Title of Change:	AR0820AT Datasheet Update		
Effective date:	09 Aug 2022		
Contact information:	Contact your local onsemi Sales Office or Joe.Faris@onsemi.com		
Type of notification:	This Product Bulletin is for notification purposes only. onsemi will proceed with implementation of this change upon publication of this Product Bulletin.		
Change Category:	Technical Documentation		
Change Sub-Category(s):	Datasheet/Product Doc change		
Sites Affected:			
onsemi Sites		External Foundry/Subcon Sites	
None		None	
Description and Purpose:

Old Figure 19

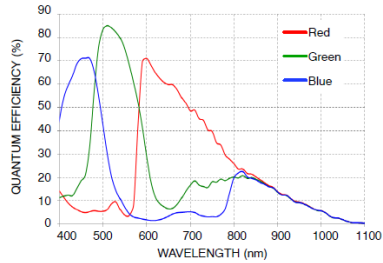
2. Updated Spectral Characteristics section with the latest quantum efficiency curves.
